Contract No. T200411209.01
Federal Aid Project No. ESTP-S028(8)
SR 24, Mulberry Knoll to SR 1
Sussex County

Enclosed is Addendum No. 1 for the referenced contract consisting of the following:

Addendum No. 1
October 24, 2019

CONSTRUCTION PHASING, M.O.T., AND EROSION CONTROL PLAN – PHASE 1

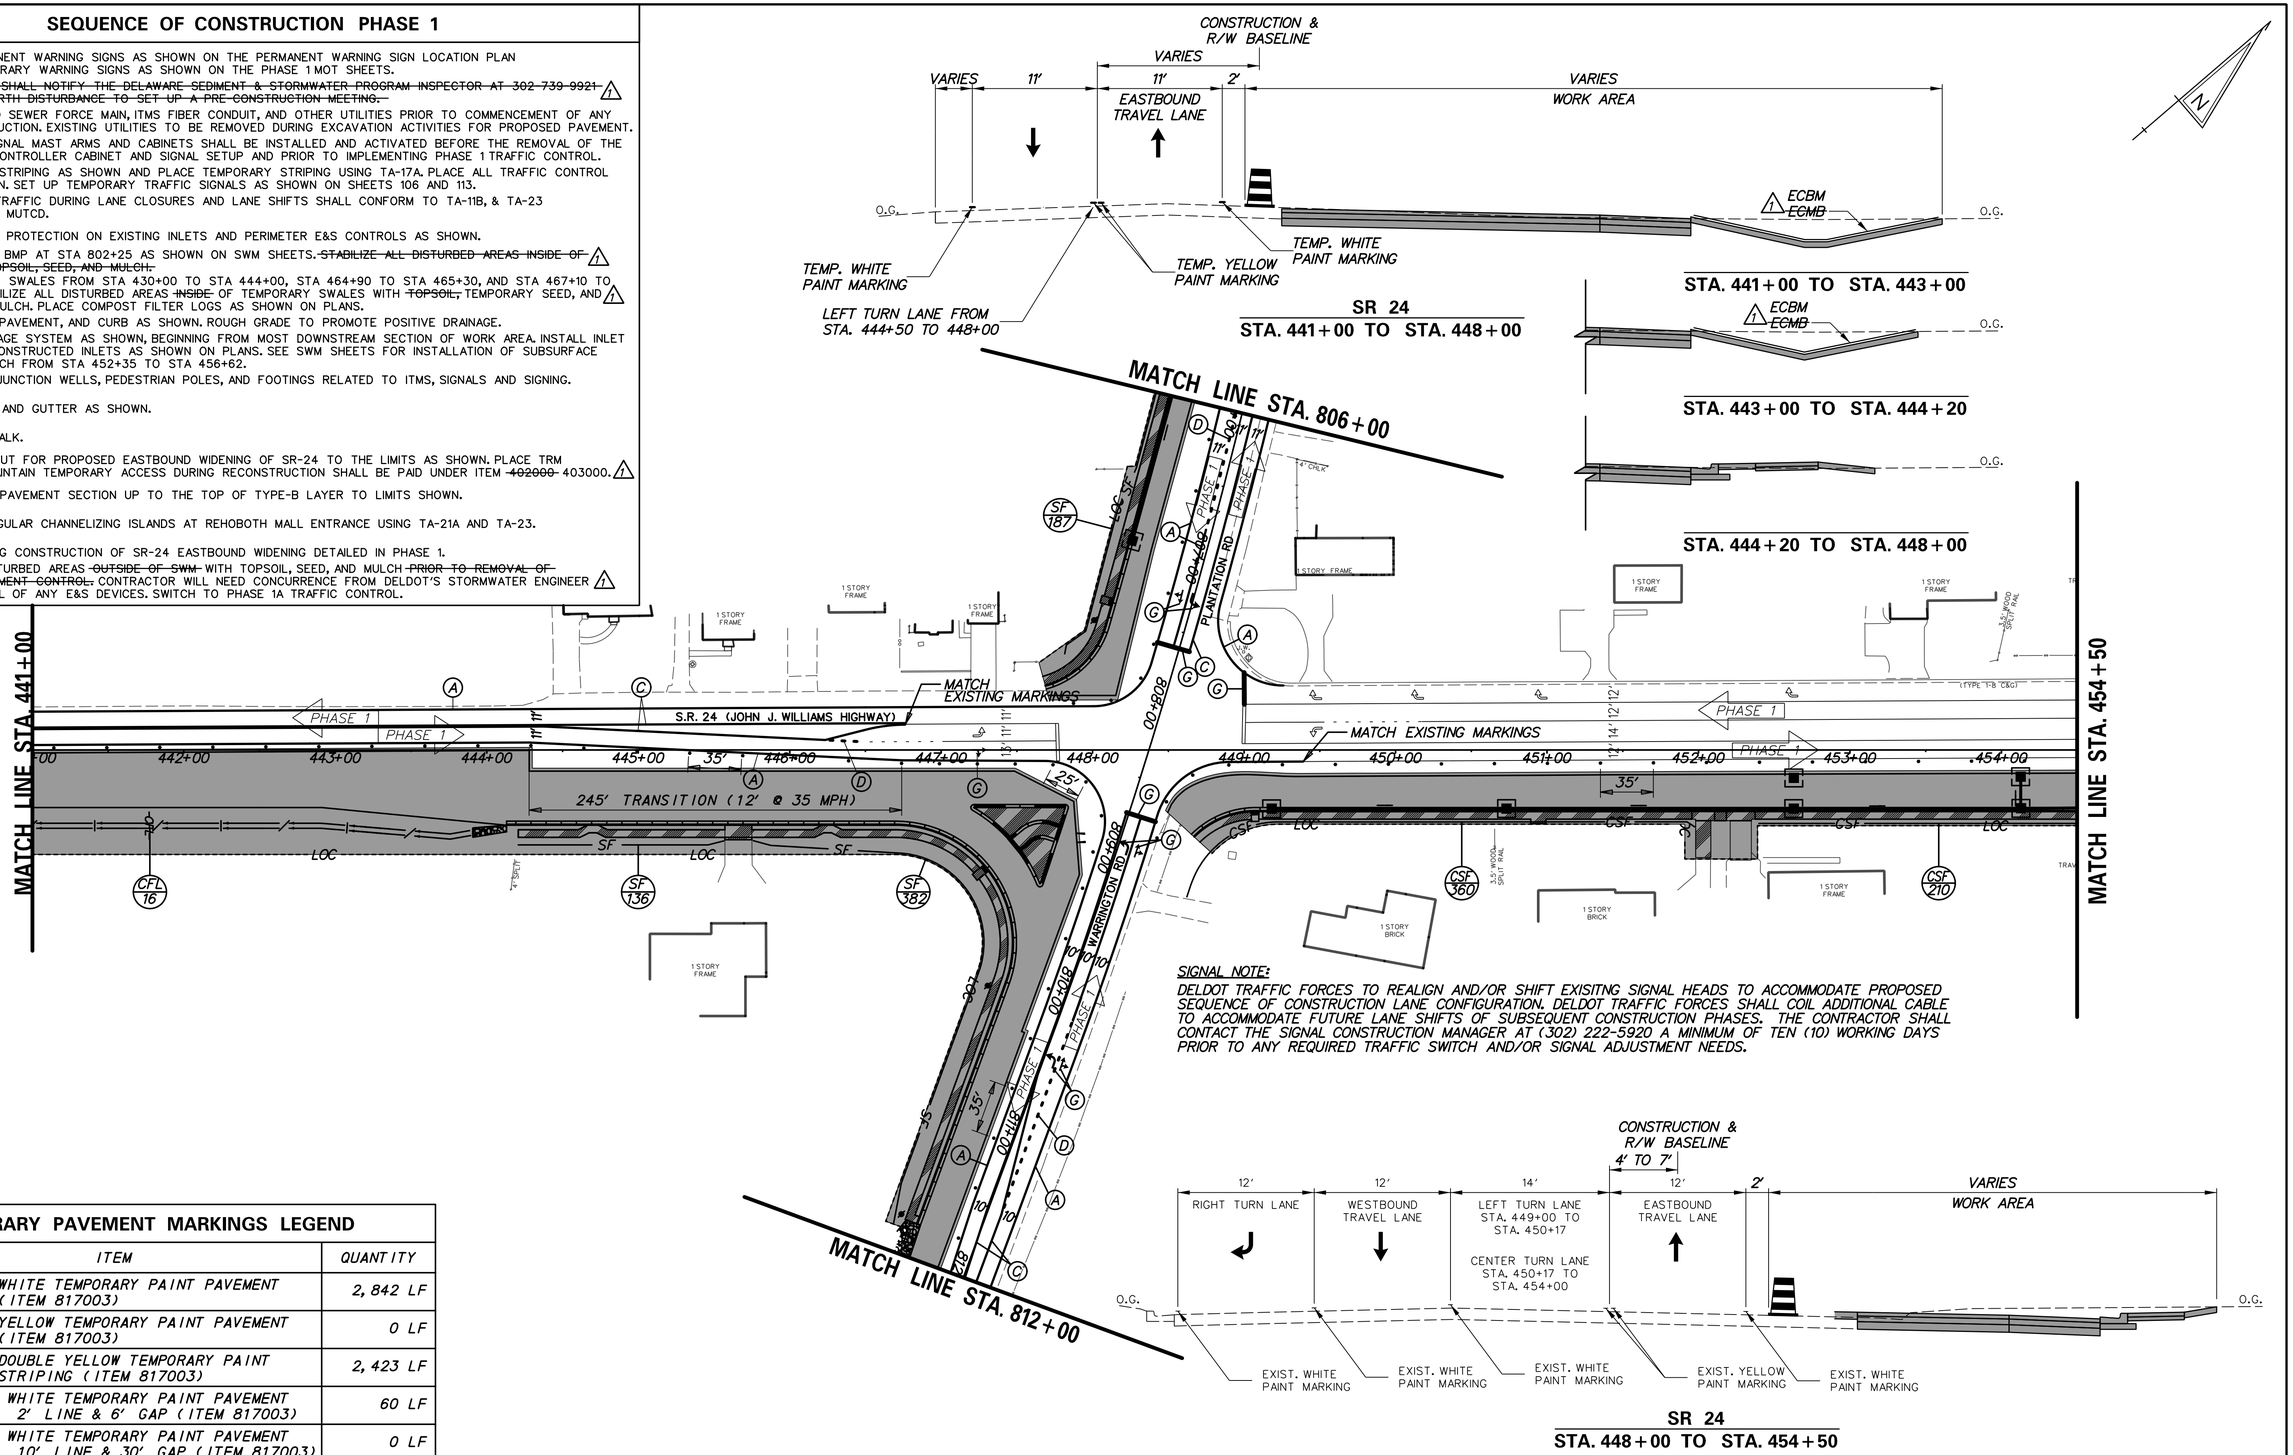
8. REGRADE EXISTING BMP AT STA 802+25 AS SHOWN ON SWM SHEETS. ~~STABILIZE ALL DISTURBED AREAS INSIDE OF SWM BMP WITH TOPSOIL, SEED, AND MULCH.~~ 1
9. GRADE TEMPORARY SWALES FROM STA 430+00 TO STA 444+00, STA 464+90 TO STA 465+30, AND STA 467+10 TO STA 474+00. STABILIZE ALL DISTURBED AREAS ~~INSIDE~~ OF TEMPORARY SWALES WITH ~~TOPSOIL,~~ TEMPORARY SEED, AND ~~MULCH~~ BLANKET MULCH. PLACE COMPOST FILTER LOGS AS SHOWN ON PLANS. 1

18. PERFORM REMAINING CONSTRUCTION OF SR-24 EASTBOUND WIDENING DETAILED IN PHASE 1.
19. STABILIZE ALL DISTURBED AREAS ~~OUTSIDE OF SWM~~ WITH TOPSOIL, SEED, AND MULCH ~~PRIOR TO REMOVAL OF EROSION AND SEDIMENT CONTROL.~~ CONTRACTOR WILL NEED CONCURRENCE FROM DELDOT'S STORMWATER ENGINEER PRIOR TO REMOVAL OF ANY E&S DEVICES. SWITCH TO PHASE 1A TRAFFIC TRAFFIC CONTROL. 1

1 REVISED SEQUENCE OF CONSTRUCTION — D. SEMPLE 10/03/2019

CS-04
SECTION AEC
SHEET NO. 53

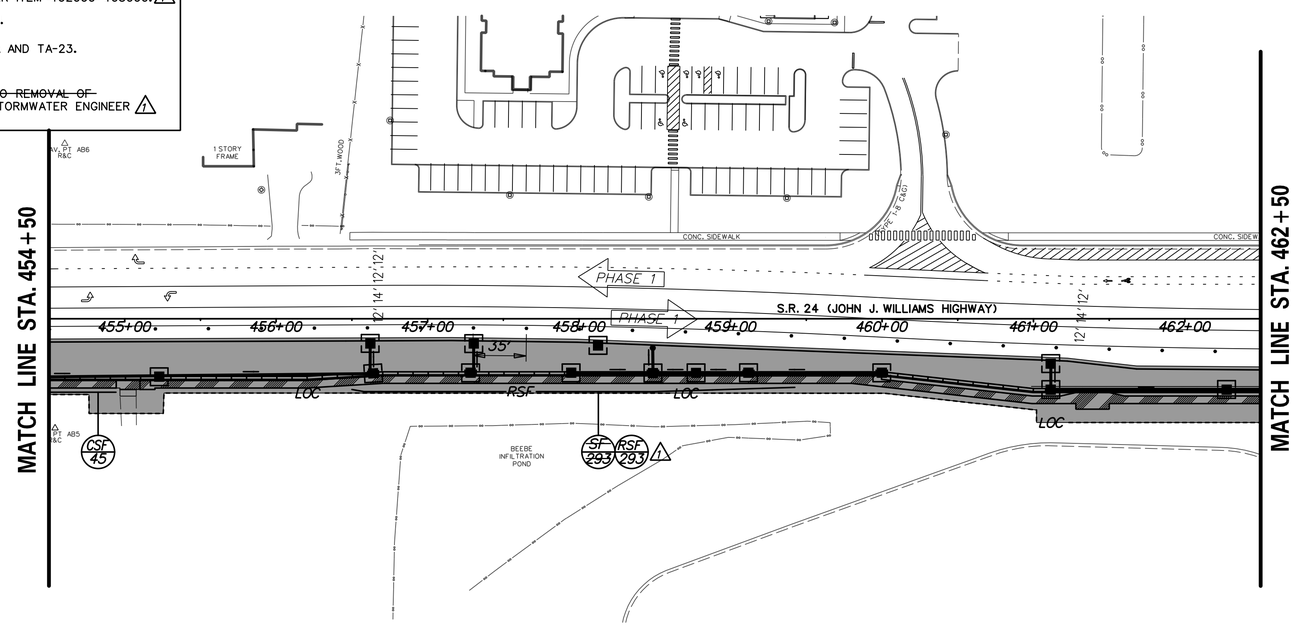
8. REGRADE EXISTING BMP AT STA 802+25 AS SHOWN ON SWM SHEETS. ~~STABILIZE ALL DISTURBED AREAS INSIDE OF SWM BMP WITH TOPSOIL, SEED, AND MULCH.~~ 1
9. GRADE TEMPORARY SWALES FROM STA 430+00 TO STA 444+00, STA 464+90 TO STA 465+30, AND STA 467+10 TO STA 474+00. STABILIZE ALL DISTURBED AREAS ~~INSIDE~~ OF TEMPORARY SWALES WITH ~~TOPSOIL,~~ TEMPORARY SEED, AND ~~MULCH~~ BLANKET MULCH. PLACE COMPOST FILTER LOGS AS SHOWN ON PLANS. 1

1 REVISED SEQUENCE OF CONSTRUCTION; SILT FENCE REVISED TO REINFORCED SILT FENCE D. SEMPLE 10/03/2019

CS–05
SECTION: AEC
SHEET NO. 54

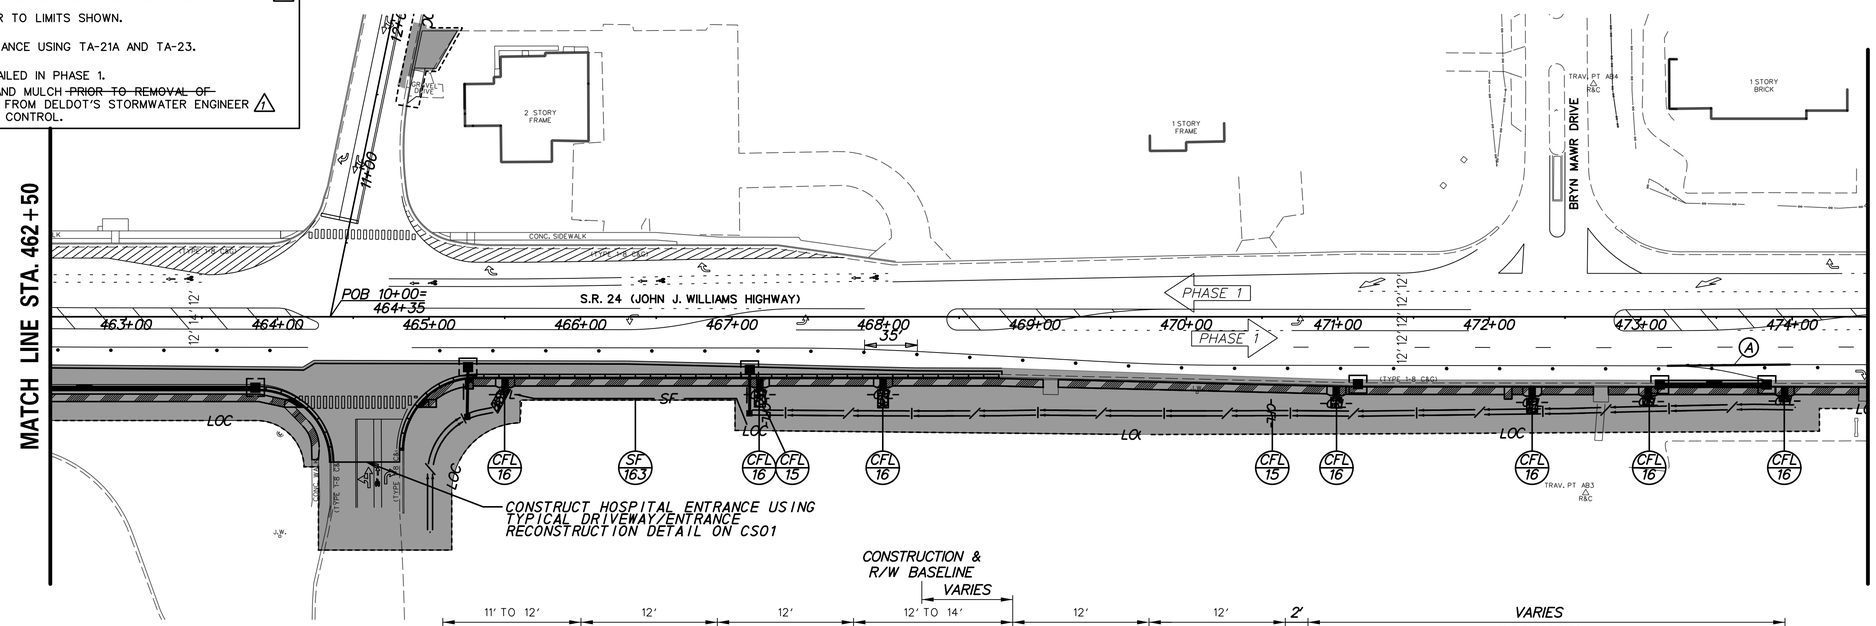
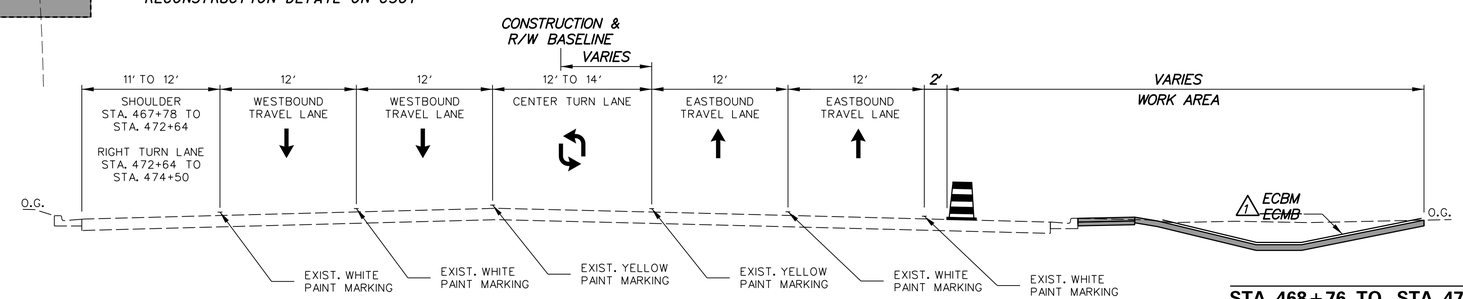
8. REGRADE EXISTING BMP AT STA 802+25 AS SHOWN ON SWM SHEETS. ~~STABILIZE ALL DISTURBED AREAS INSIDE OF SWM BMP WITH TOPSOIL, SEED, AND MULCH.~~ 1
9. GRADE TEMPORARY SWALES FROM STA 430+00 TO STA 444+00, STA 464+90 TO STA 465+30, AND STA 467+10 TO STA 474+00. STABILIZE ALL DISTURBED AREAS ~~INSIDE~~ OF TEMPORARY SWALES WITH ~~TOPSOIL,~~ TEMPORARY SEED, AND ~~MULCH~~ BLANKET MULCH. PLACE COMPOST FILTER LOGS AS SHOWN ON PLANS. 1

1	REVISED SEQUENCE OF CONSTRUCTION	D. SEMPLE 10/03/2019

CS–06
SECTION
AEC
SHEET NO.
55

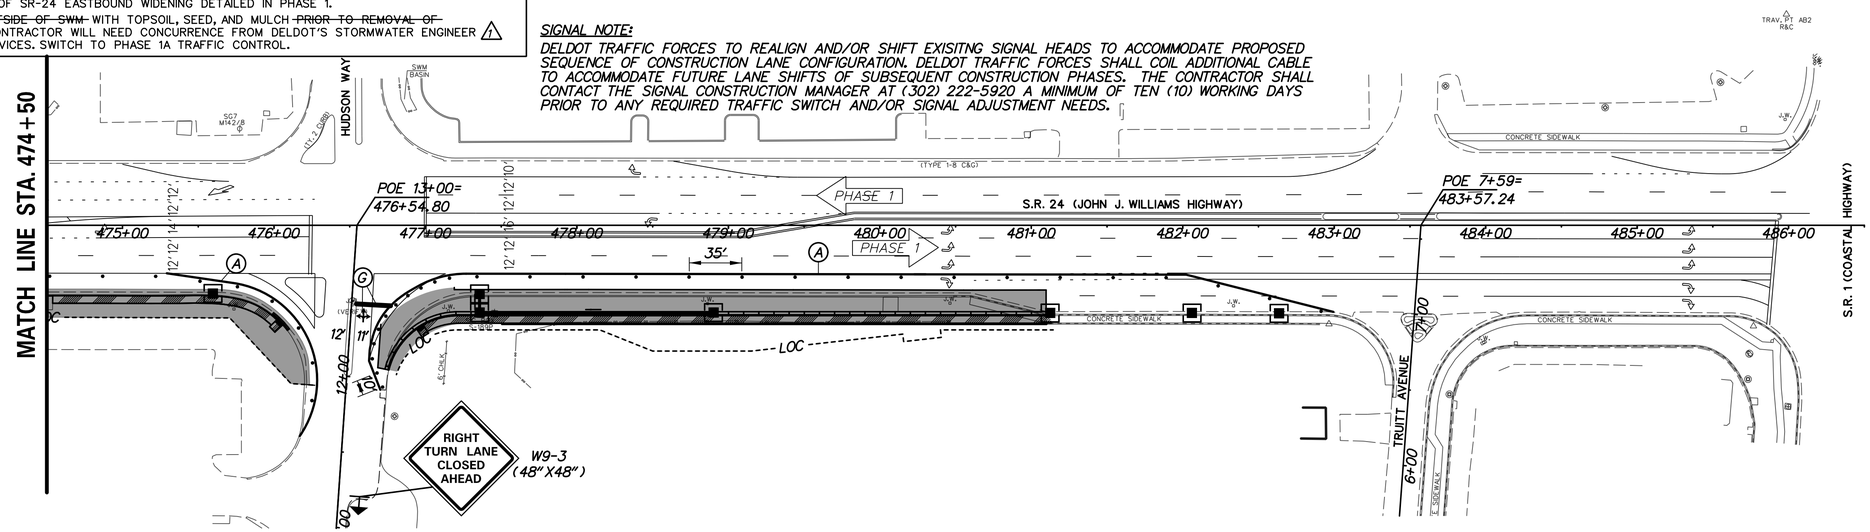
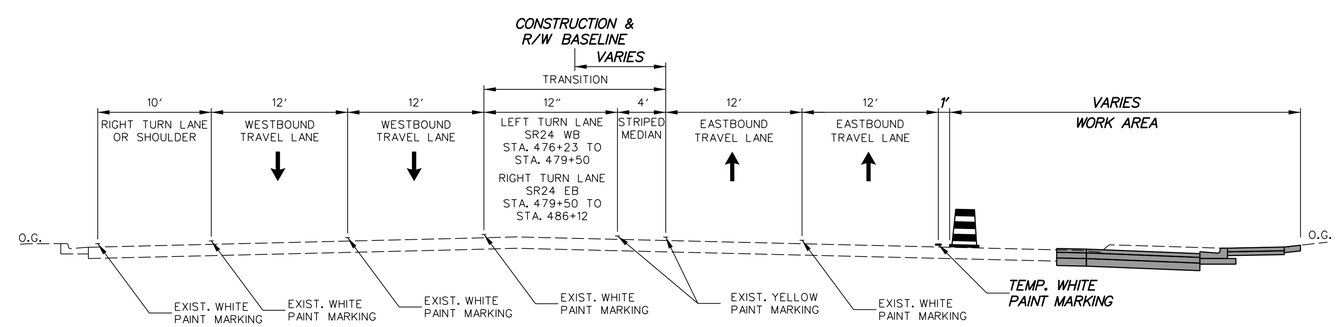
8. REGRADE EXISTING BMP AT STA 802+25 AS SHOWN ON SWM SHEETS. ~~STABILIZE ALL DISTURBED AREAS INSIDE OF SWM BMP WITH TOPSOIL, SEED, AND MULCH.~~ 1
9. GRADE TEMPORARY SWALES FROM STA 430+00 TO STA 444+00, STA 464+90 TO STA 465+30, AND STA 467+10 TO STA 474+00. STABILIZE ALL DISTURBED AREAS ~~INSIDE~~ OF TEMPORARY SWALES WITH ~~TOPSOIL,~~ TEMPORARY SEED, AND ~~MULCH~~ BLANKET MULCH. PLACE COMPOST FILTER LOGS AS SHOWN ON PLANS. 1

1	REVISED SEQUENCE OF CONSTRUCTION	D. SEMPLE 10/03/2019

CS–07
SECTION
AEC
SHEET NO.
56

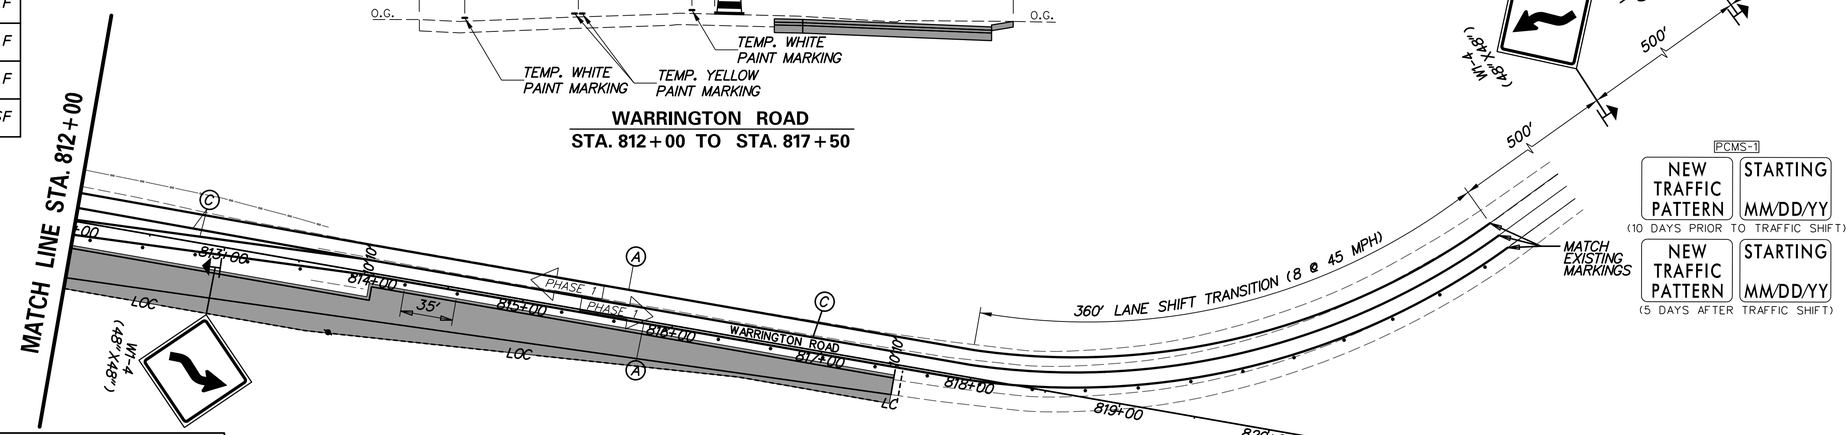
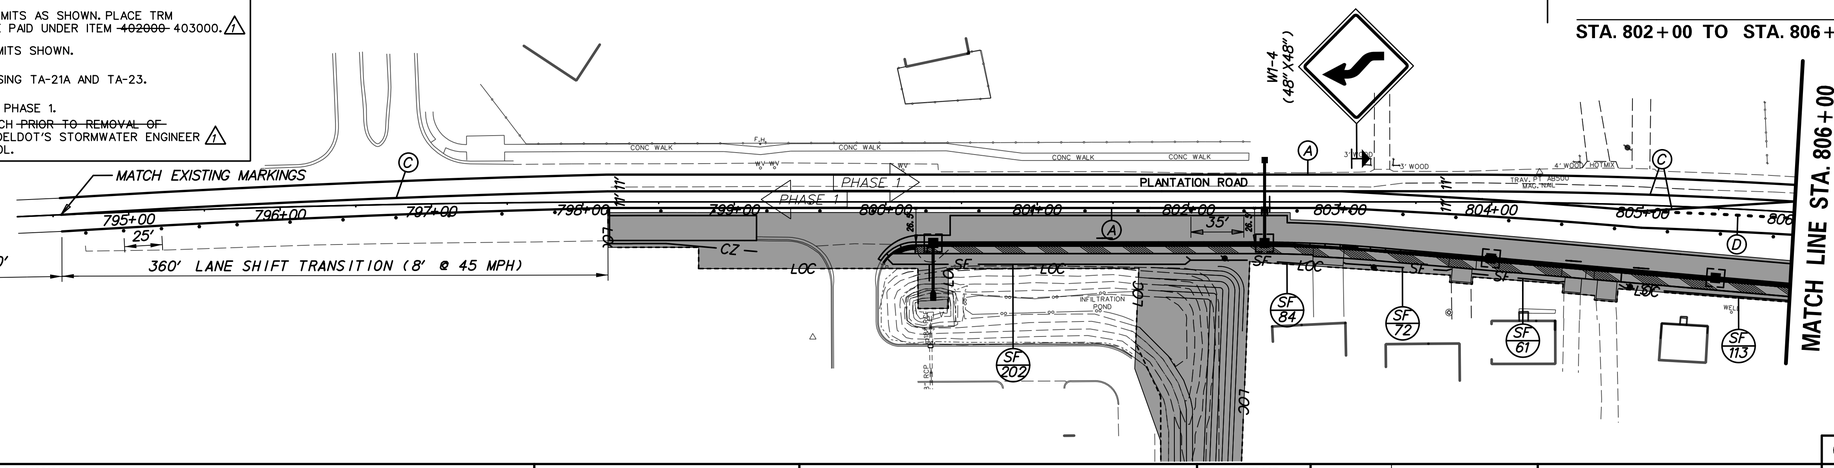
8. REGRADE EXISTING BMP AT STA 802+25 AS SHOWN ON SWM SHEETS. ~~STABILIZE ALL DISTURBED AREAS INSIDE OF SWM BMP WITH TOPSOIL, SEED, AND MULCH.~~ 1
9. GRADE TEMPORARY SWALES FROM STA 430+00 TO STA 444+00, STA 464+90 TO STA 465+30, AND STA 467+10 TO STA 474+00. STABILIZE ALL DISTURBED AREAS ~~INSIDE~~ OF TEMPORARY SWALES WITH ~~TOPSOIL,~~ TEMPORARY SEED, AND ~~MULCH~~ BLANKET MULCH. PLACE COMPOST FILTER LOGS AS SHOWN ON PLANS. 1

ADDENDA / REVISIONS		
1 REVISED SEQUENCE OF CONSTRUCTION	D. SEMPLE 10/03/2019
